STATEMENT OF CASE

20/0008/LRB

**REVIEW AGAINST REFUSAL OF PLANNING PERMISSION
REF. 19/01861/PP**

**LAND SOUTH WEST OF 1 ROYAL COTTAGE
PIER ROAD, INNELLAN, DUNOON, ARGYLL**

1 of 8	1:1250	Location Plan;
2 of 8	1:200	Block Plan;
3 of 8	1:100	Proposed Ground Floor Plan;
4 of 8	1:100	Proposed First Floor Plan;
5 of 8	1:100	Proposed North Elevation;
6 of 8	1:100	Proposed South Elevation;
7 of 8	1:100	Proposed East Elevation;
8 of 8	1:100	Proposed West Elevation.

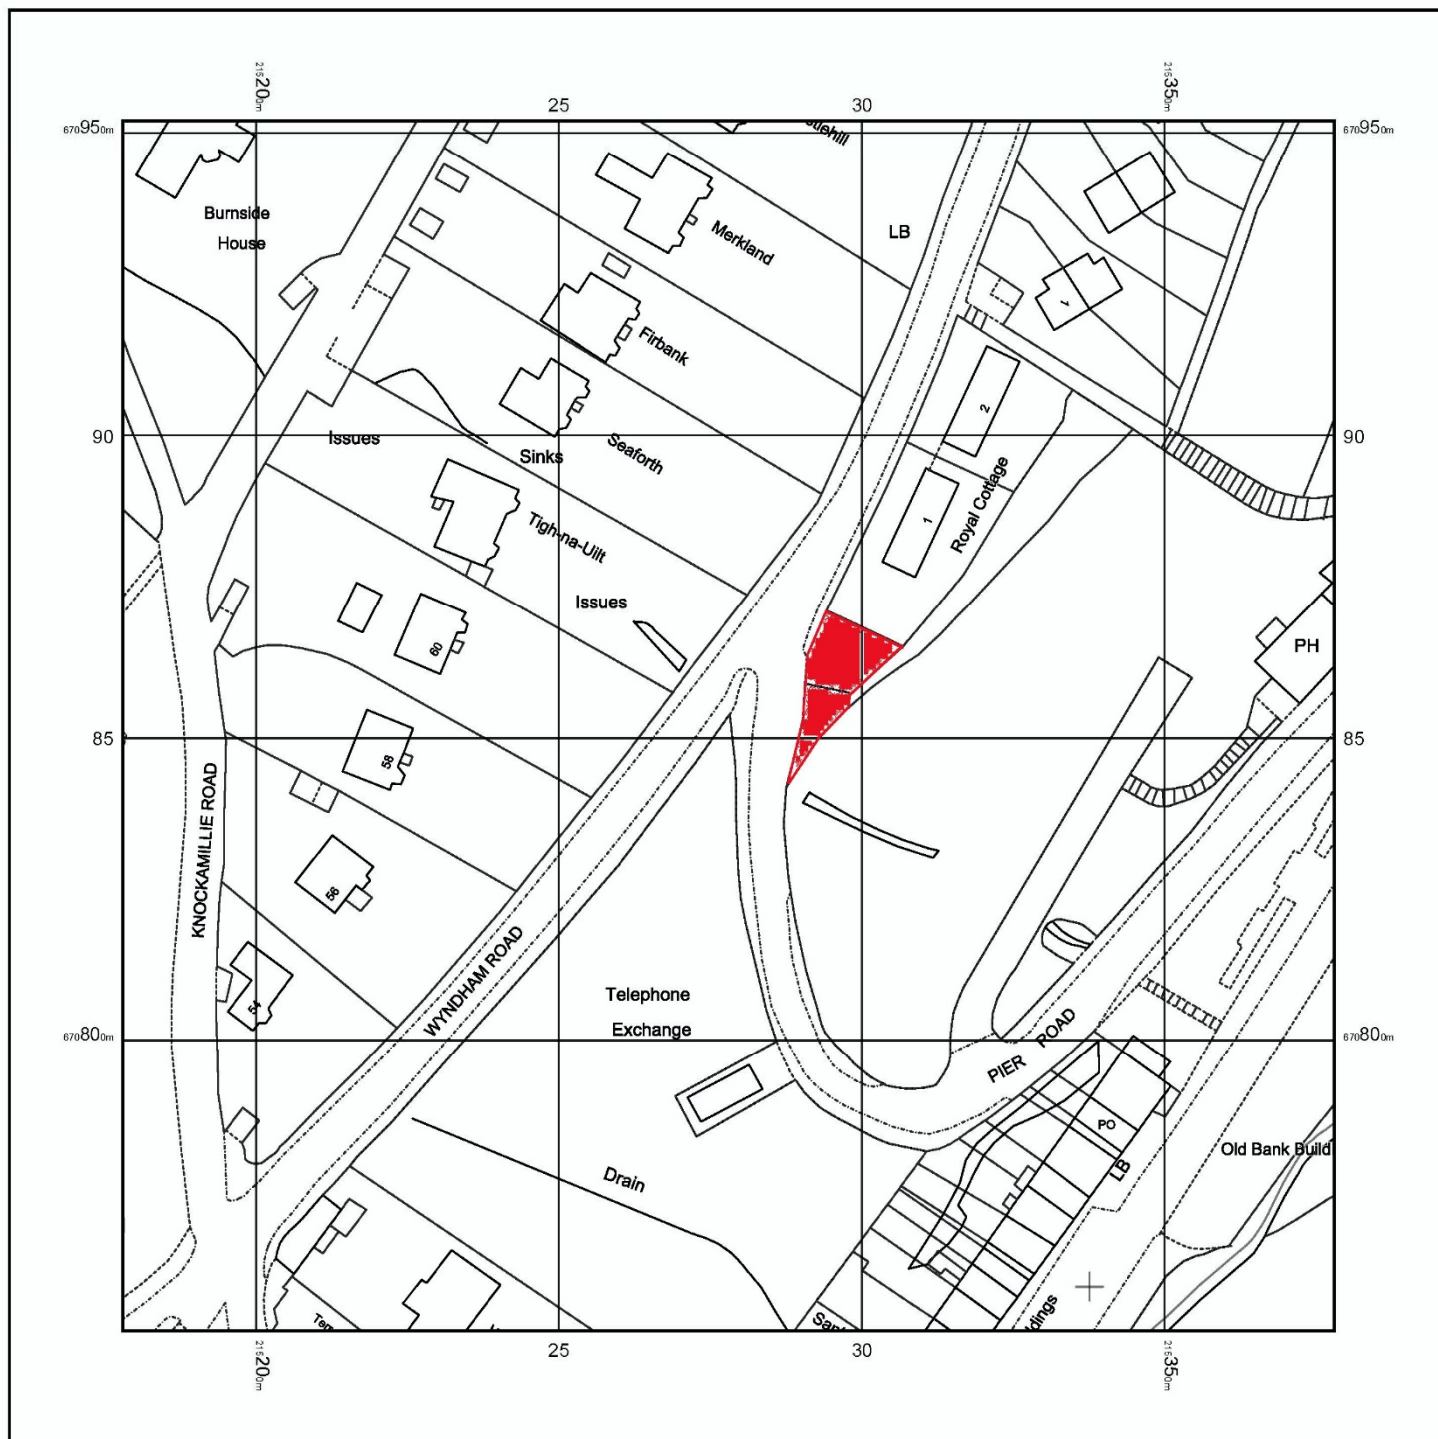
Planning response: Design can be a subjective matter but in this case, the poor quality submission coupled with a poor design concept on a confined site was found to be unacceptable by the Case Officer, Area Team Leader and Divisional Manager. Design Guidance is contained within the Argyll and Bute Local Development Plan Supplementary Guidance including Sustainable Siting and Design Principles and also within the Council's Sustainable Design Guidance documents 1 to 4.

Planning response: The proposed dwellinghouse displays a mixture of window openings leading to cluttered elevations. The appellant had been invited to submit a Design Statement to explain the rationale for his particular design but no Design Statement was ever submitted nor did the department have any opportunity to discuss the scheme in more detail with the appellant despite emails 4th October 2019, 4th November 2019, 4th December 2019 and 23rd December 2019. [Production nos. 5, 7, 8 & 9].

Planning response: The submitted drawings were considered to be of such poor architectural quality that the upper section of the dwellinghouse appeared 'box-like' with a flat roof. The appellant was invited to submit a Design Statement to explain the rationale for his particular design but no Design Statement was submitted nor did the department have any opportunity to discuss the scheme in more detail with the appellant despite emails dated 4th October 2019, 4th November 2019, 4th December 2019 and 23rd December 2019 [Production nos. 5, 7, 8 & 9]. For the record, the department is not against the use of flat roofs or mono-pitch roofs on modern dwellinghouses provided the overall design concept is acceptable.

Planning response: The poor quality drawings and lack of a Design Statement explaining how the proposed building works and its relationship to its amenity spaces resulted in a negative recommendation. The small overgrown triangular site (182sqm) has very limited opportunities for meaningful amenity space which was not ably demonstrated by the appellant in his submission. For these reasons, it was considered that the erection of a dwellinghouse on the site together with its car parking and turning facilities would result in over-development of the restricted application site and offer very limited amenity spaces for the proposed dwelling.

2. The proposed dwellinghouse would not represent acceptable rounding-off development as the required sightlines onto Pier Road cannot be provided. The required southbound visibility splay is located on land outwith the applicant's control. Furthermore, the existing access requires significant improvements to provide a safe vehicular access. Without these necessary improvements, the proposal would result in an intensification of traffic movements on Pier Road using a sub-standard access. The proposed development is considered to be inconsistent with the provisions of the Development Plan and approval could only be obtained if the visibility splays and access design issues can be addressed. With this in mind the proposal as currently submitted is not capable of achieving the required standards as per SG LDP TRAN4 New and Existing Public Roads and Private Access Regimes of the Argyll and Bute Local Development Plan.

3. The siting of the proposed dwellinghouse in close proximity to two protected deciduous trees (Tree Preservation Order 04/04) would result in a significant impact to these trees. Development so close to these trees and their root systems would inevitably result in a significant adverse impact to these trees and accordingly contrary to policies LDP 3 and SG LDP ENV6 of the Argyll and Bute Local Development Plan which states that the Council will resist development likely to have an adverse impact on trees by ensuring through the development management process that adequate provision is made for the preservation of and where appropriate the planting of new woodland/trees, including compensatory planting and management agreements.

4. It is proposed to install a private sewage treatment plant with soakaway to a nearby burn in an area that can potentially be served by connection to the public sewer system. Accordingly, the proposed development is considered to be contrary to policies LDP 11 and SG LDP SERV 1 of the Argyll and Bute Local Development Plan.
